Review of Planning Application

The ISSA Memorial Garden (Muslim Cemetery & Pavillion) Blackburn Road

Ref: M3491-PAR-21.12.14

Review of Planning Application
submitted with outline application 11/21/0622
Land south of Blackburn Road, Oswaldtwistle
By Barnes Walker

EPS Plan UK21.5655-001A- Inappropriate Cut and Fill

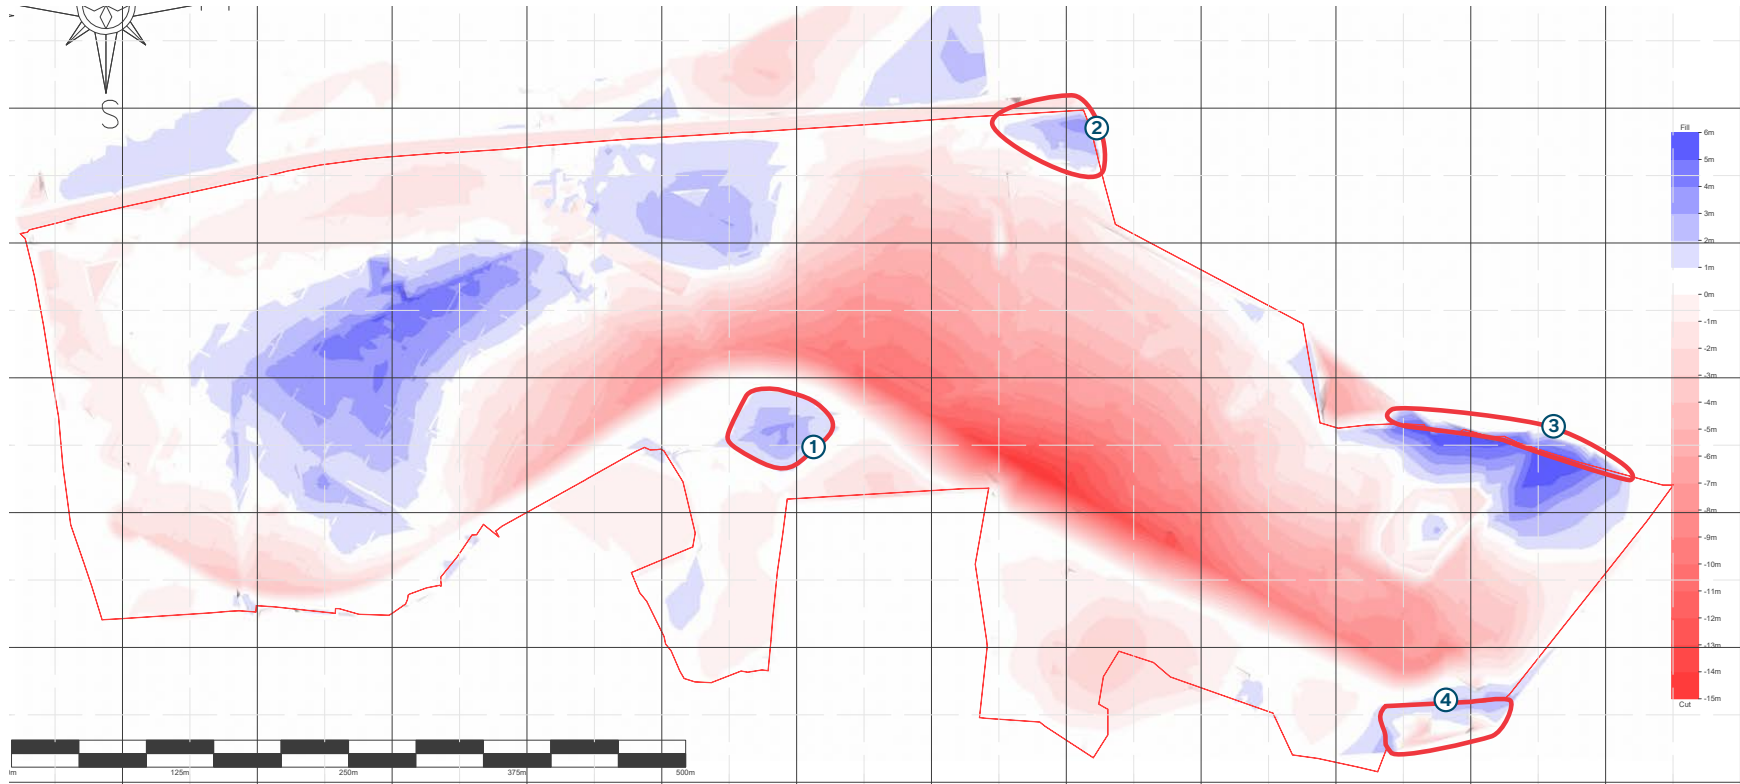
- Position 1 – A 3-4 high knoll is proposed at the top of the new 10m high embankment making a 14m high feature.
- Position 2 – This fill will raise the level of the car park 3m above Blackburn Road and there is no allowance to grade down to adjacent land off site. (Is a retaining wall intended?).
- Position 3 – up to 5m of fill is proposed across neighbours' gardens and in certain instances into their living rooms? A wall of earth would be presented to these neighbouring properties.
- Position 4 – up to 3m of fill is proposed across neighbouring gardens and again in certain instances fill is proposed into the living rooms of certain properties?

Assuming these fill proposals are wrong this further exacerbates the cut proposals and the amount of material to be exported.

A true representation of Existing Slopes

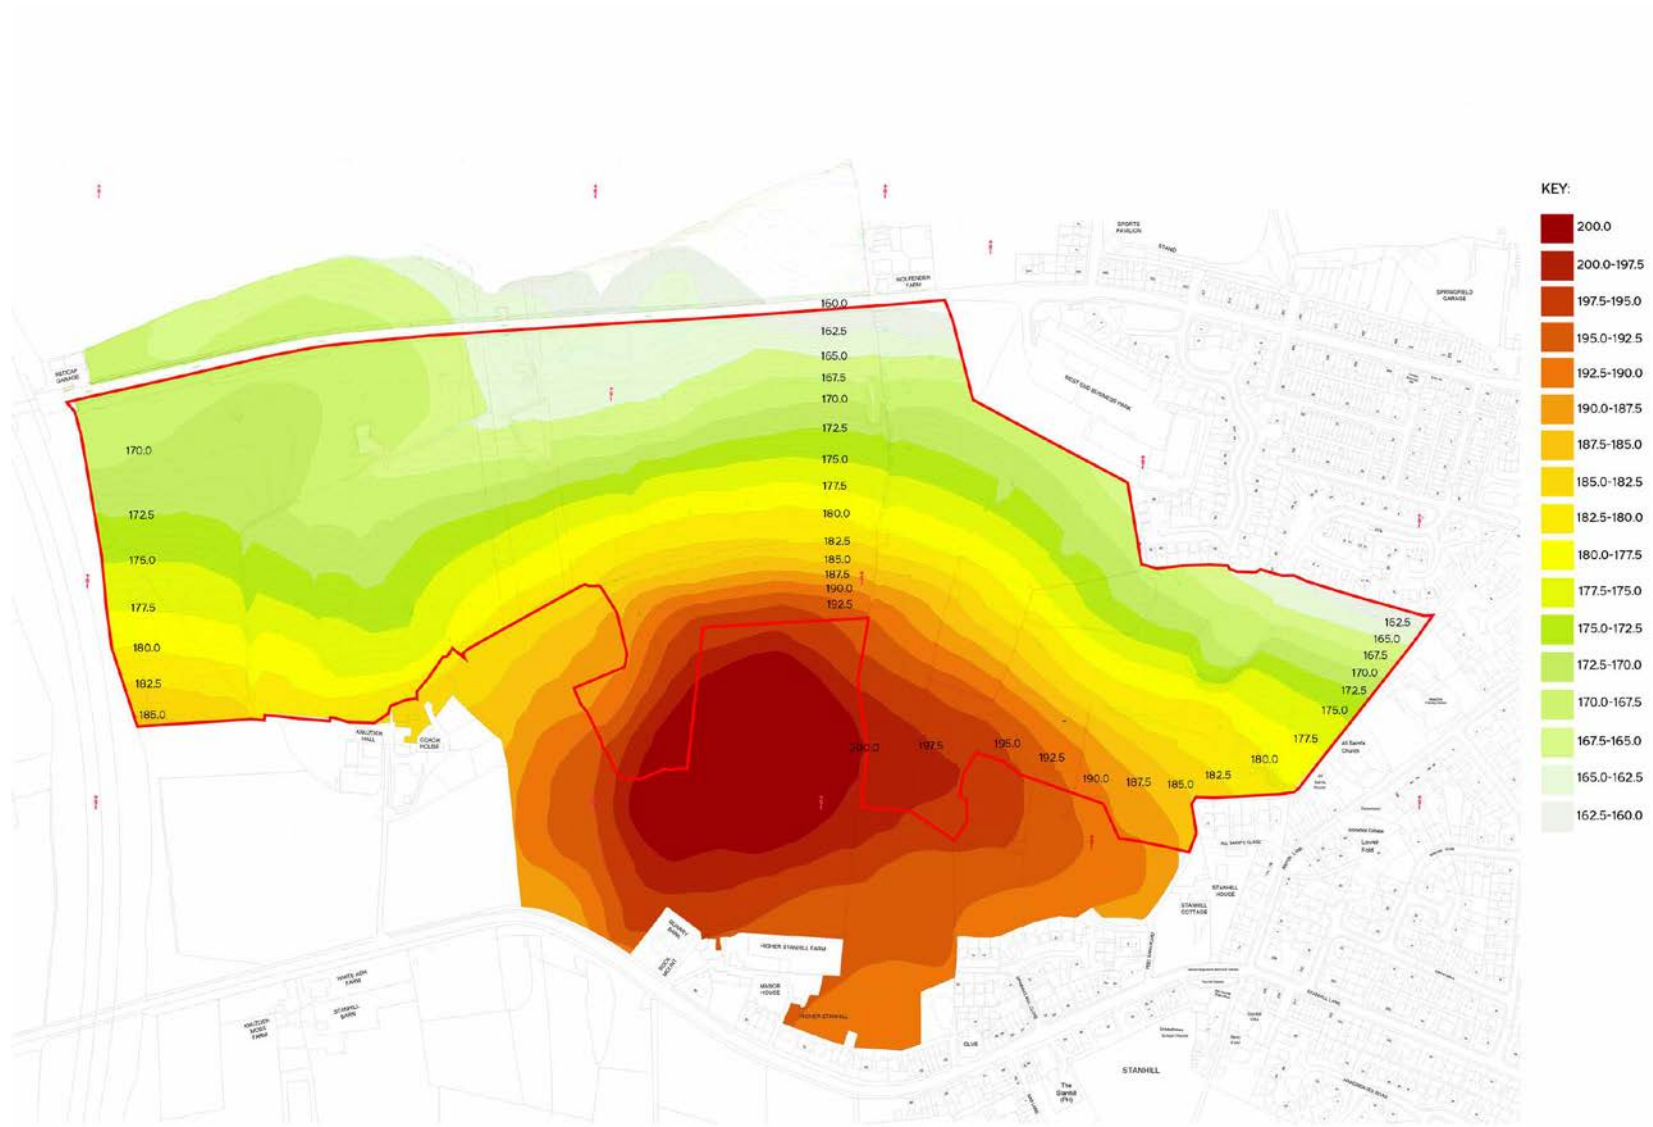
Refer to Existing and Proposed Situation Contour Plans which show accurate representations for the colour gradation between contours.

- 3.4 The existing digital terrain modelling (p.10 of the DAS & drawing number UK21.5655_Geo0018 rev. A) creates a contoured map of the existing landform. However, the colours used seemingly underplay the significant existing level changes across the site through the use of a green colour which at first glance appears to show that the main body of the site is largely flat (green), but the green band covers a change in levels of circa 15-20m. The incremental grading of the green colour range is not clearly apparent when compared with the yellow (circa 5m range before it becomes clearly orange (5m) and then red). It could be argued that that this presentation technique has been employed to divert attention away from the significant level changes currently experienced across the application site and to hide the enormity of the required excavation works required to make the scheme "work".

The submitted representation of Existing Slopes

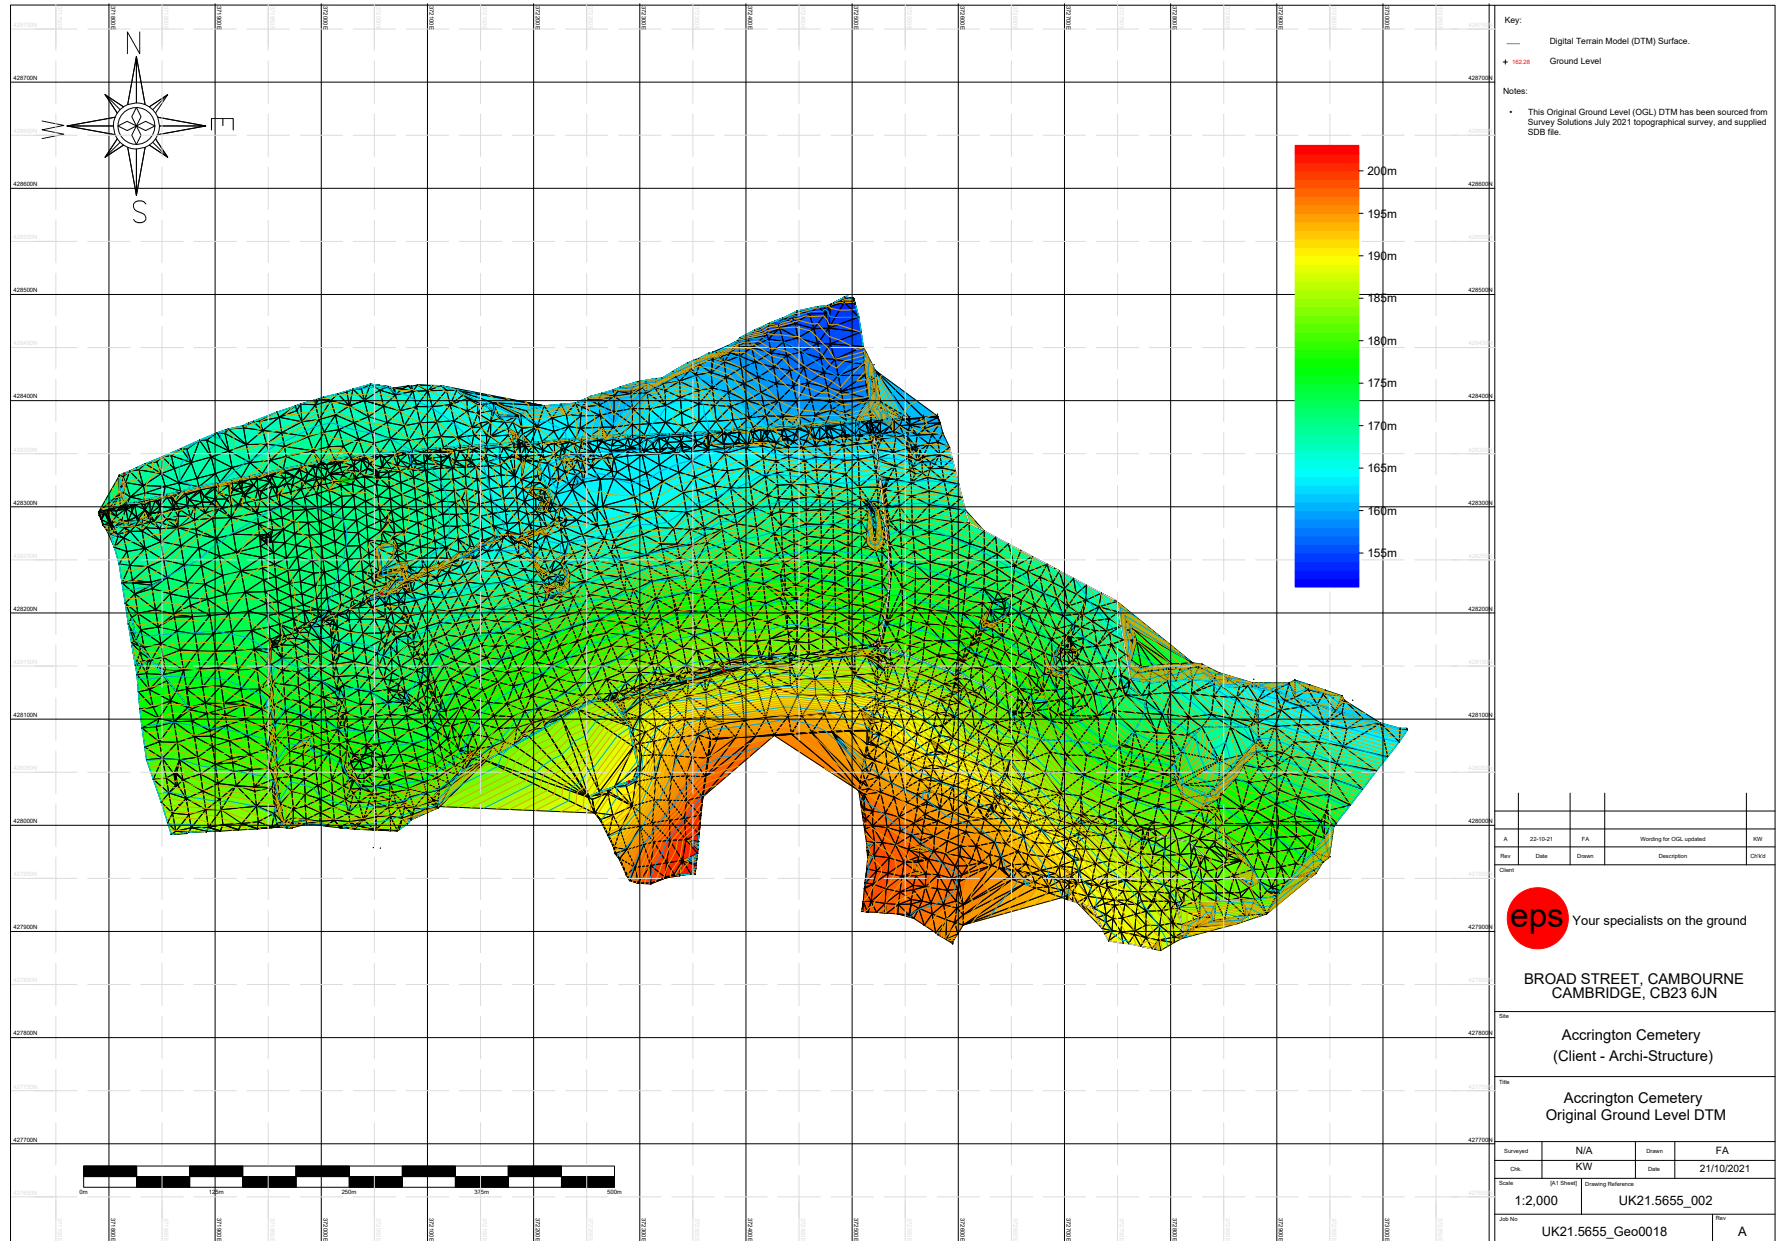
Furthermore, the use of the green colour range for the site levels means that the significant level changes/excavation between the existing and proposed situations are equally as notably diluted through the contoured colour scheme utilised.

A true representation of Proposed Slopes

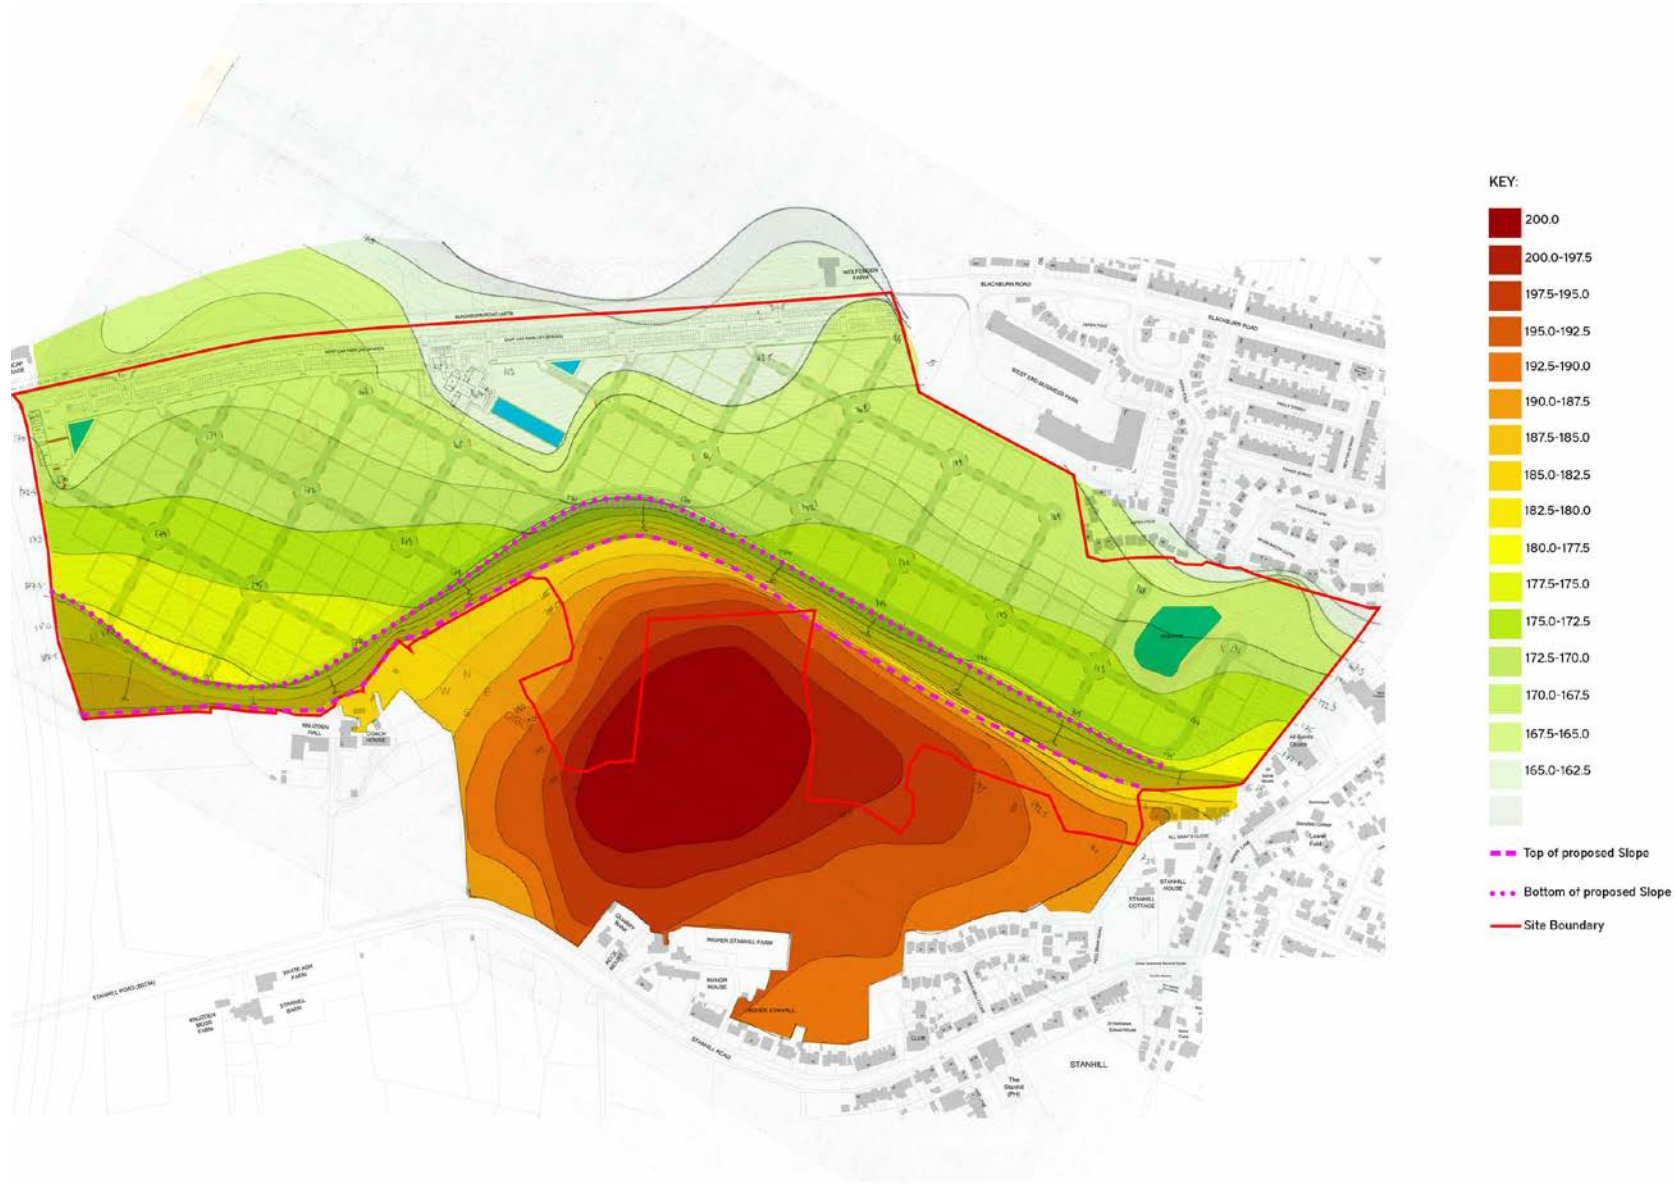
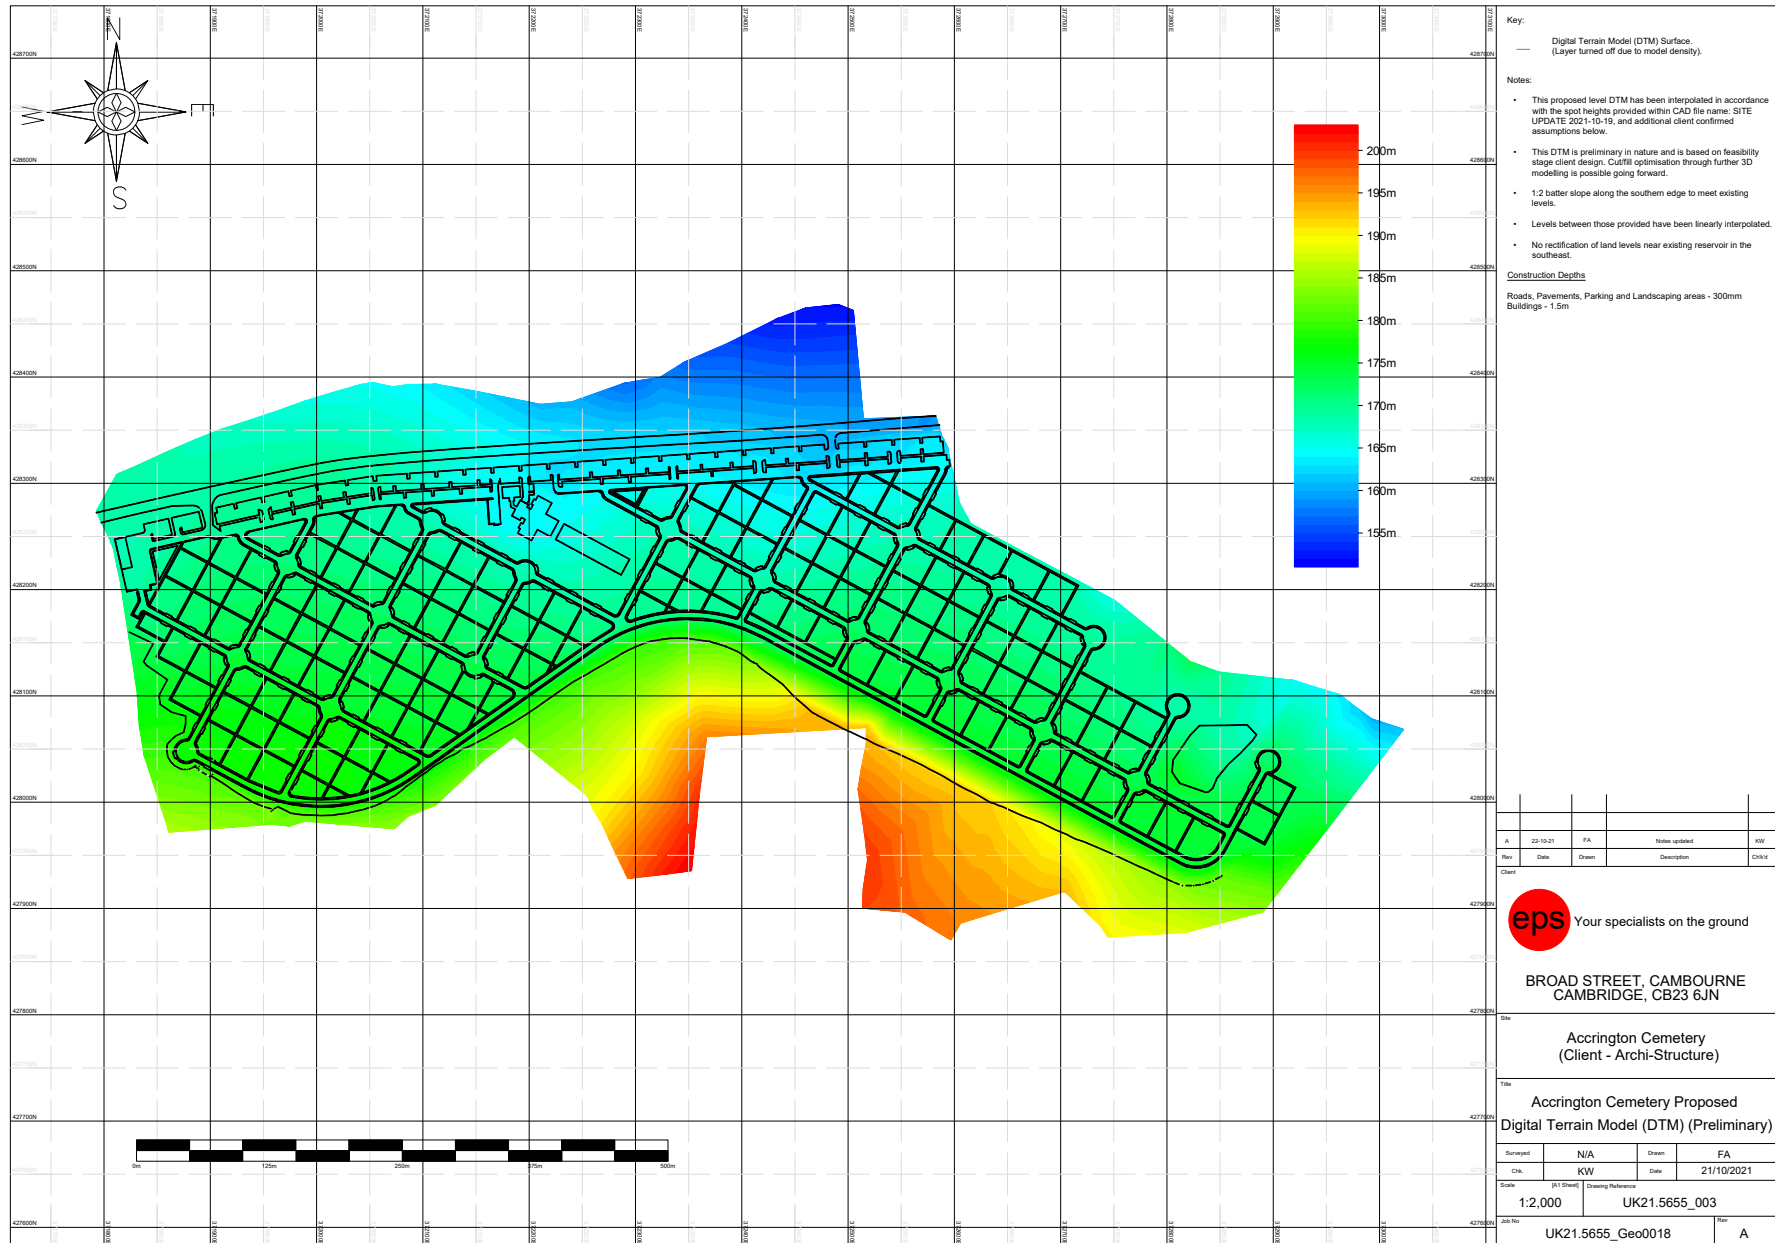
The Master Site Plan and Proposed Landscape Masterplan do not graphically differentiate between significant banks created (12m+) and the smaller banks created (circa 2m). The generic extent of the "Slope" graphic does not tell the 3-D "story".
